ADDENDUM NO. 04

Date of Issuance: January 7, 2025

Project: **2024 Jersey Village High School Renovation**
 Cypress-Fairbanks Independent School District

Texas Arcadis Inc.
 Project No.: 202319

4 1ST FLOOR - CORRIDOR H099 FLOOR PATTERN
1/8" = 1'-0"

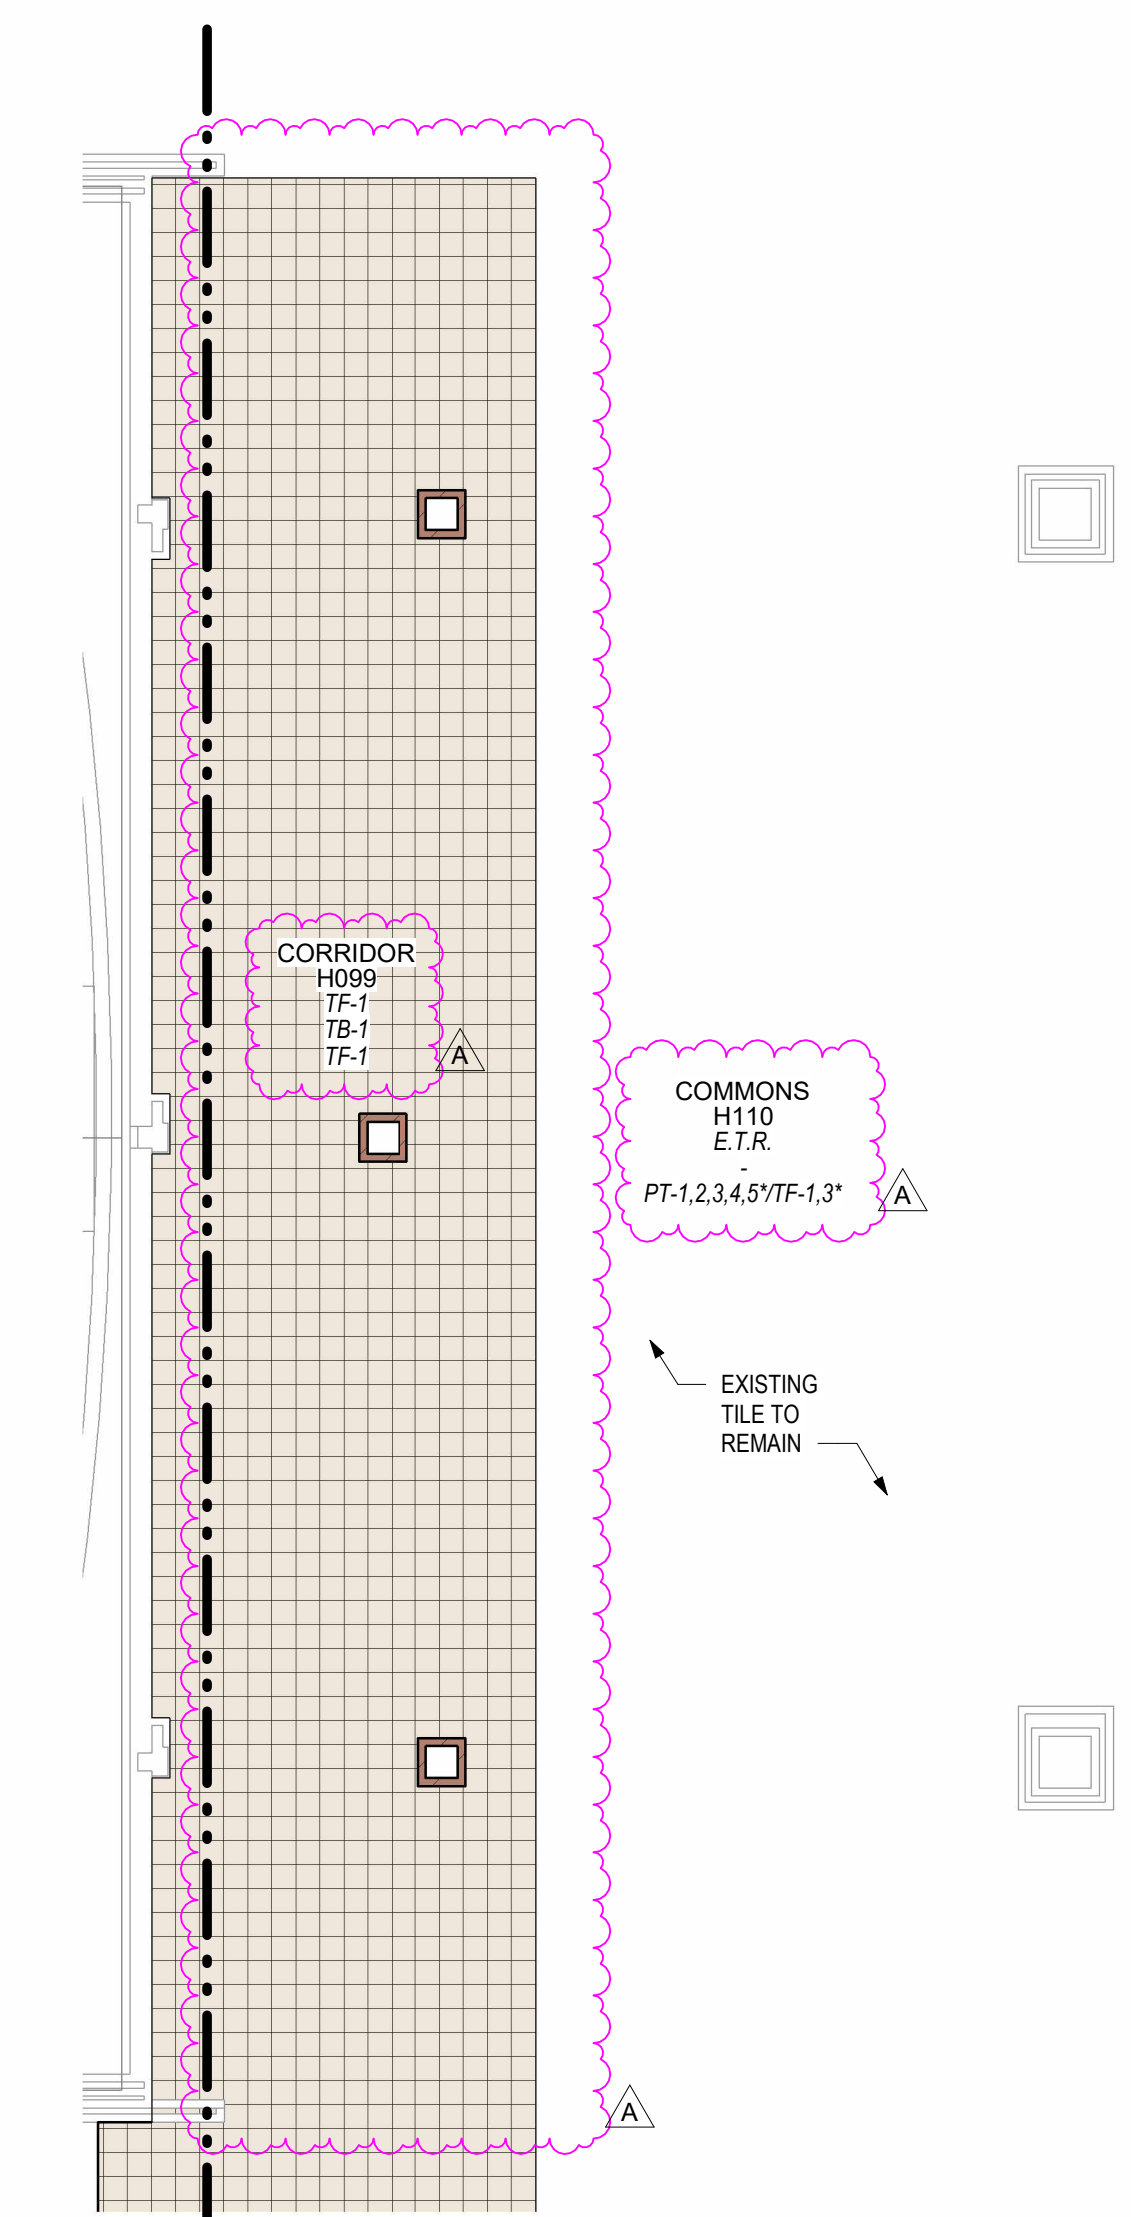
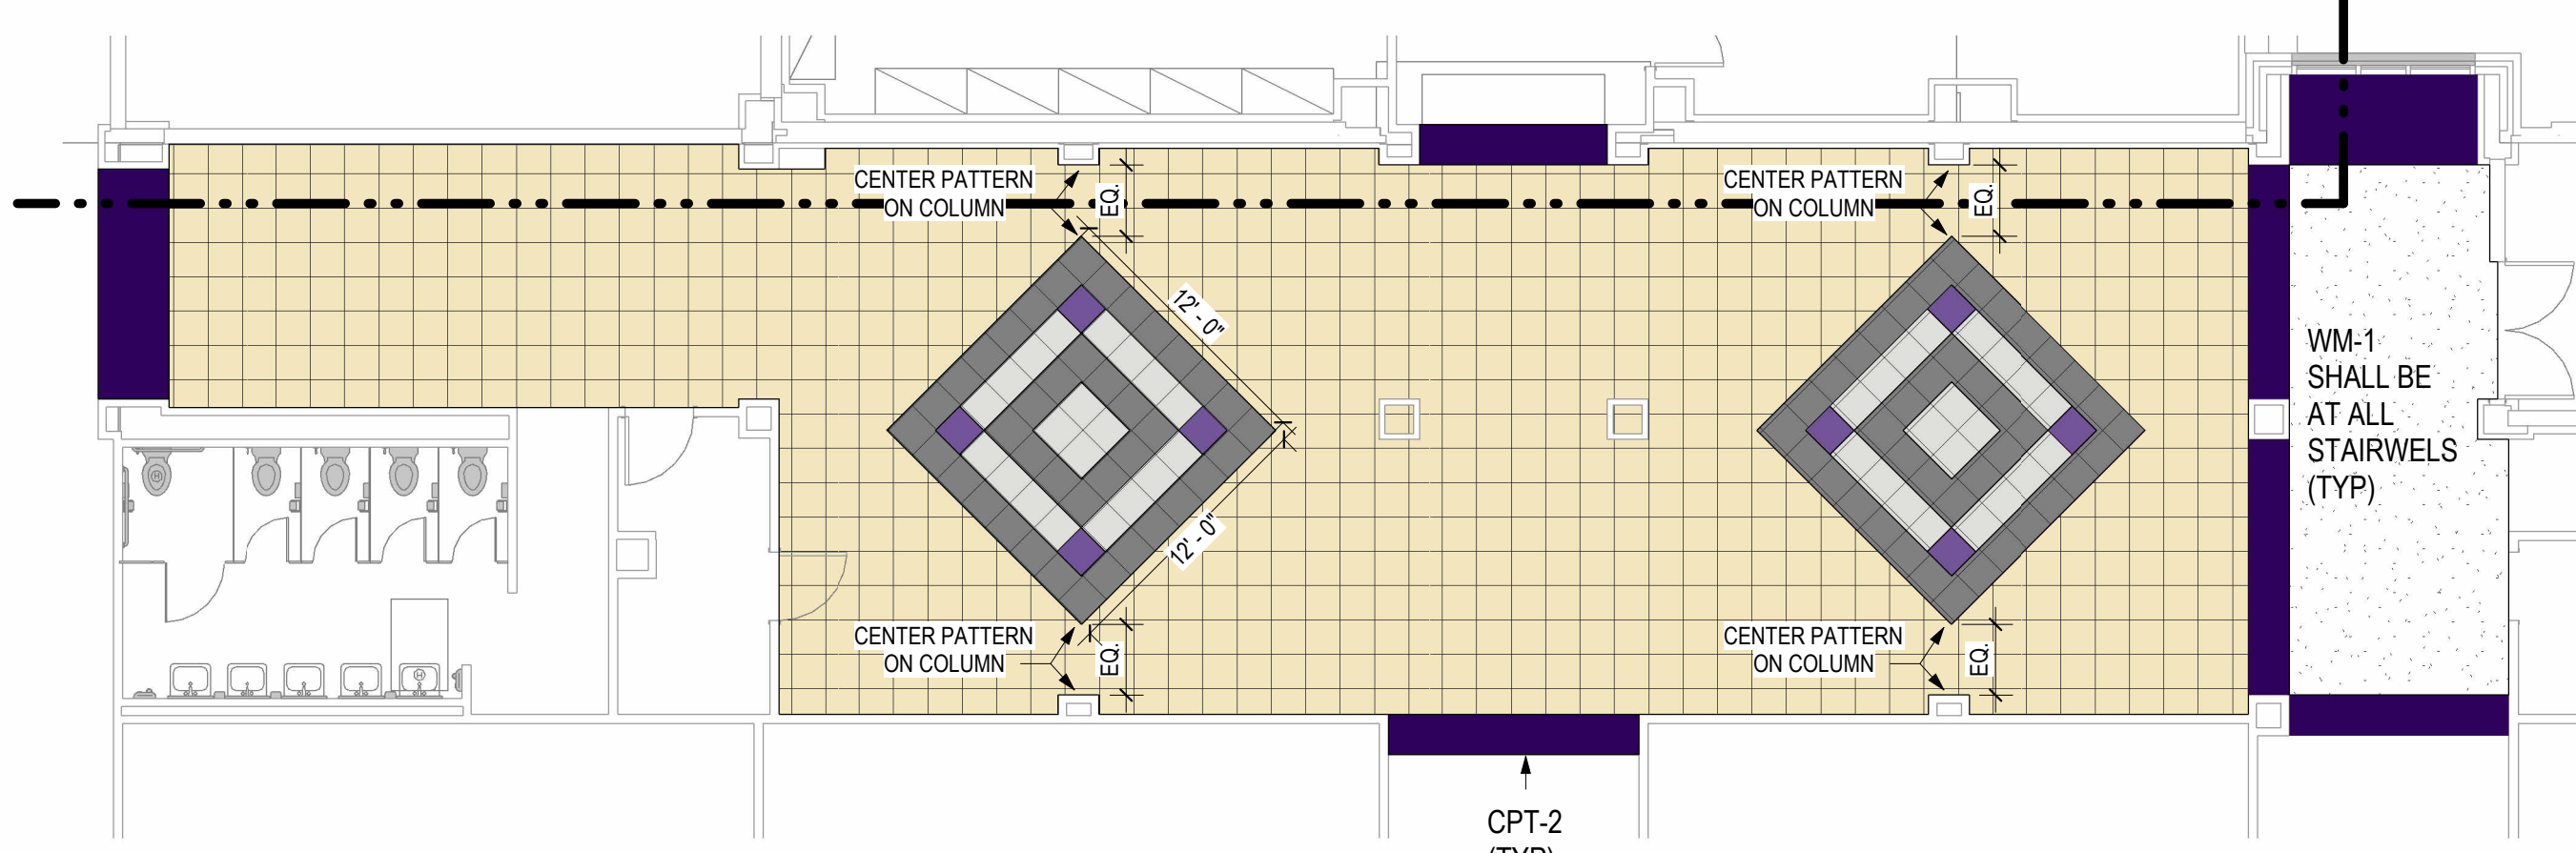
- a. Incorporate flooring changes to Commons H110, Corridor H099, and Serving P101 on drawings 4 and 5 per reissued sheet.
